**Medway DPW Water Quality Treatment  
Facility Site Plan – 19 Populatic Street**

**SUBJECT: Populatic Water Treatment Plant – Major Site Plan Review  
19 Populatic Street, Medway, Massachusetts**

Wright-Pierce has received Tetra Tech's comments on the Major Site Plan Review submission for the Populatic Water Treatment Plant project. We have prepared the following letter and attachments in response to these comments.

DRAWING  
A-201

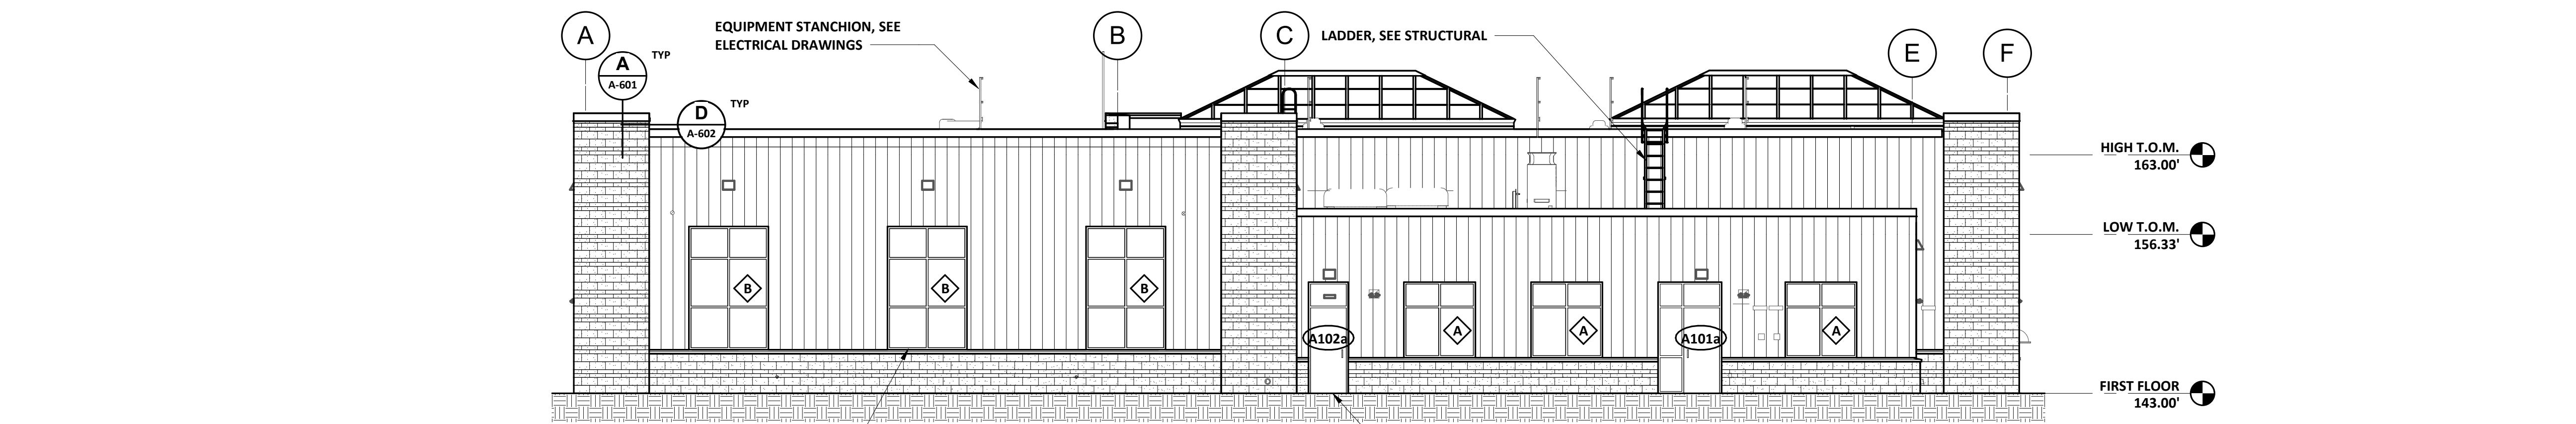
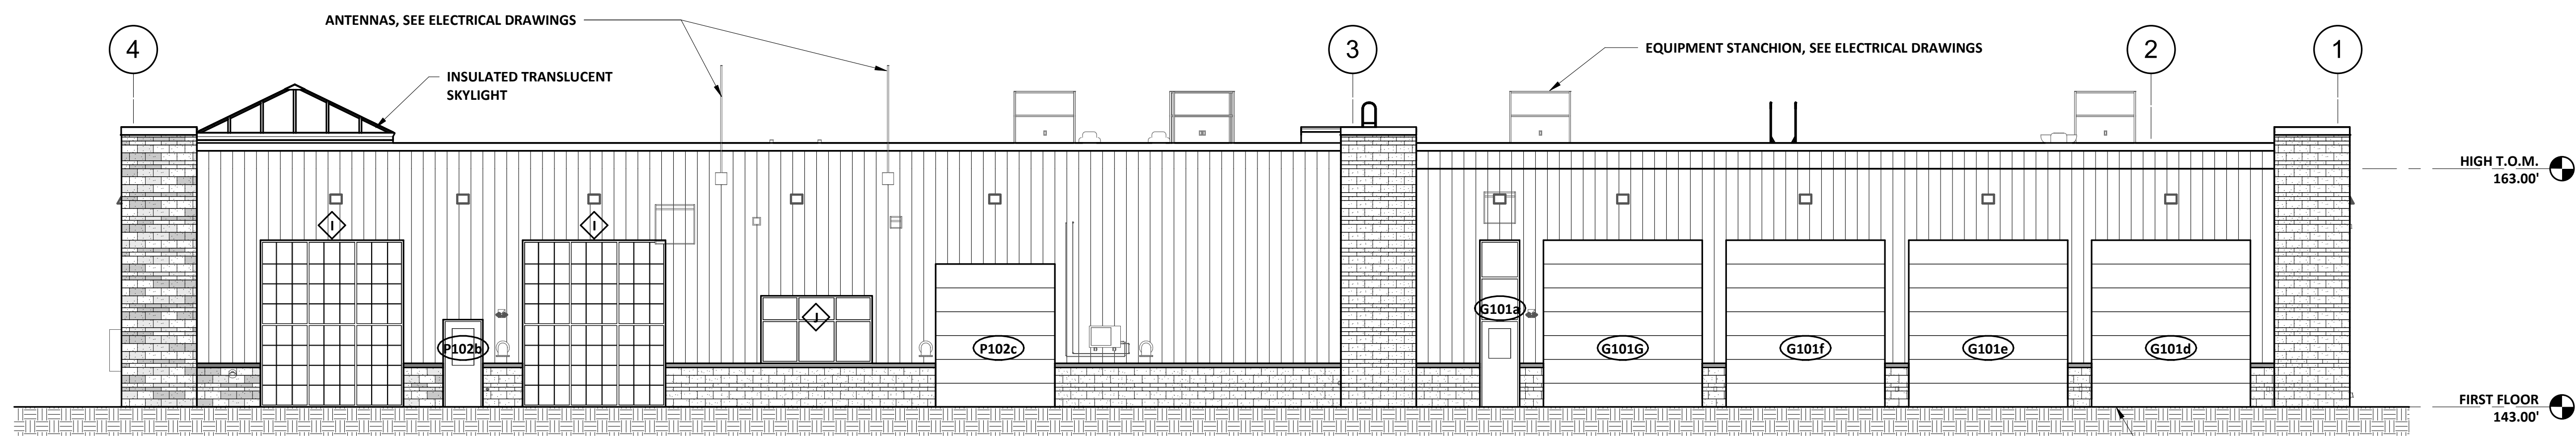
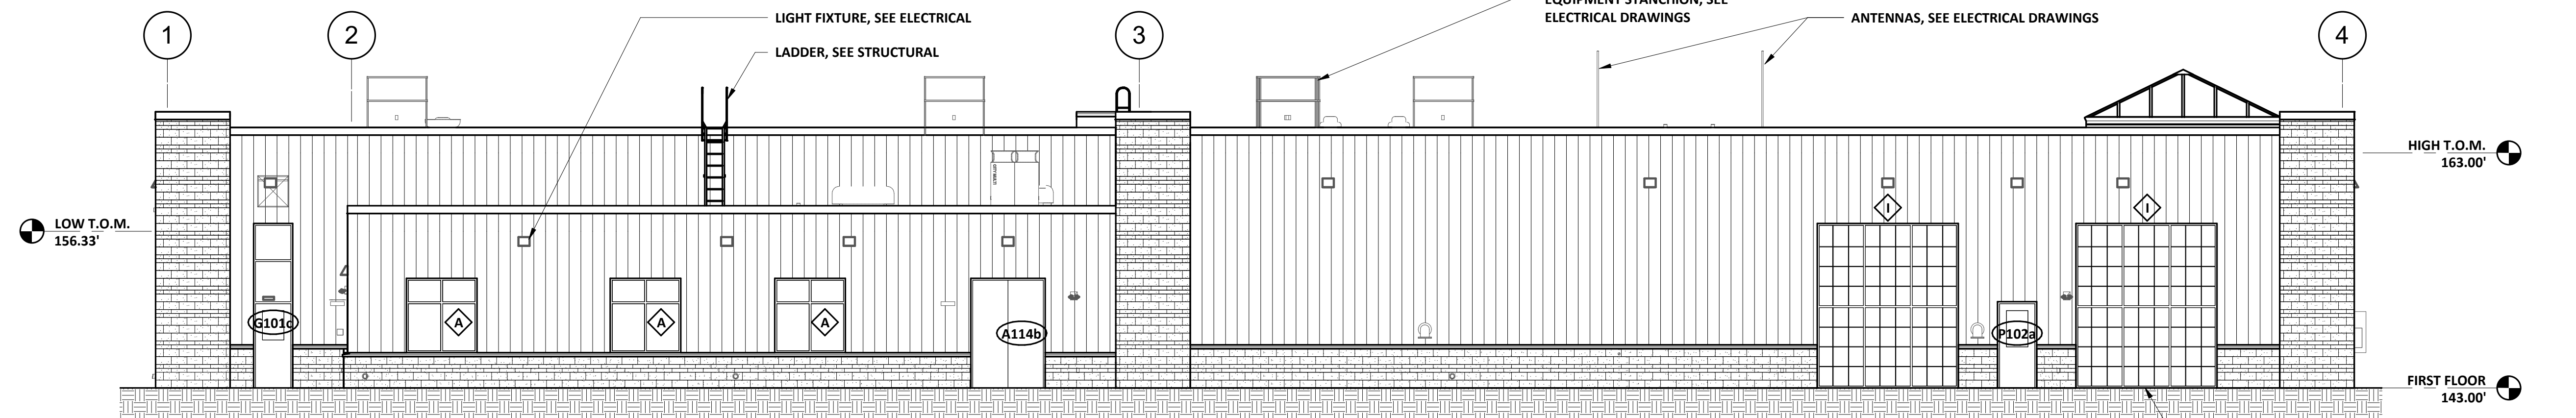
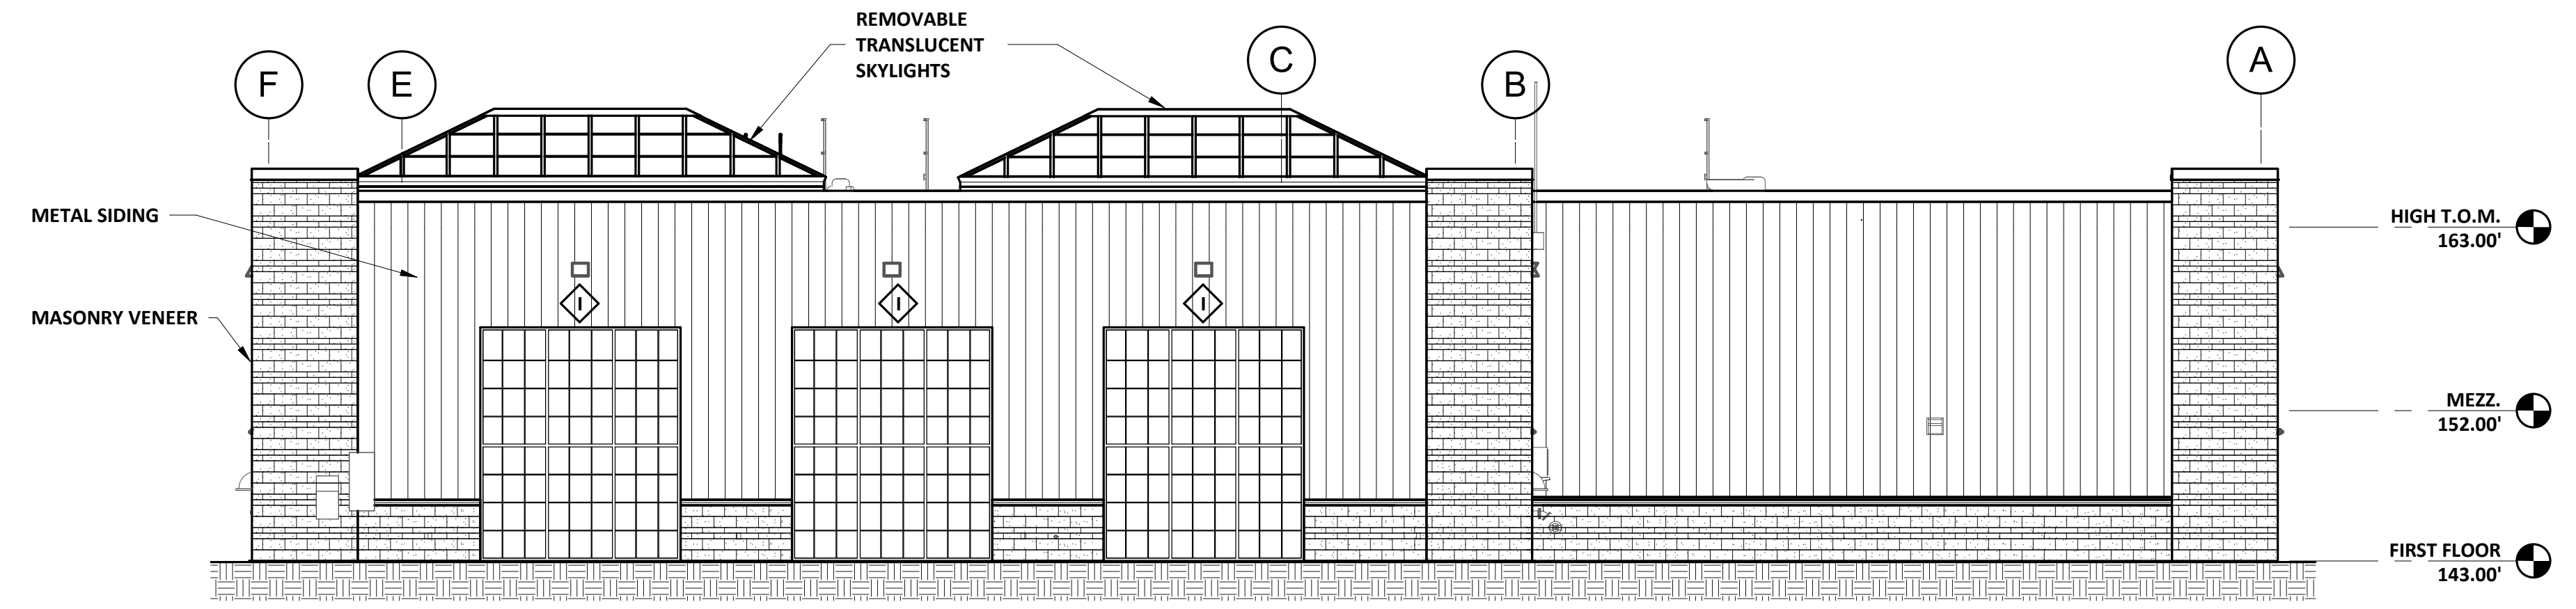
14. The Applicant has provided a lighting plan showing 26 proposed light sources connected to the building with no proposed light trespass on abutting properties. Height of luminaires should be specified along with the hours of illumination. TT also recommends the lighting symbols be better represented on the lighting plan as it is hard to determine the location of each proposed lamp. (Ch. 200 §204-5.D.15)

*shown on Sheet A-201. The photometric plan shows no light spillover onto Populatic Street or adjacent properties. Refer to revised drawings in Attachment C.*
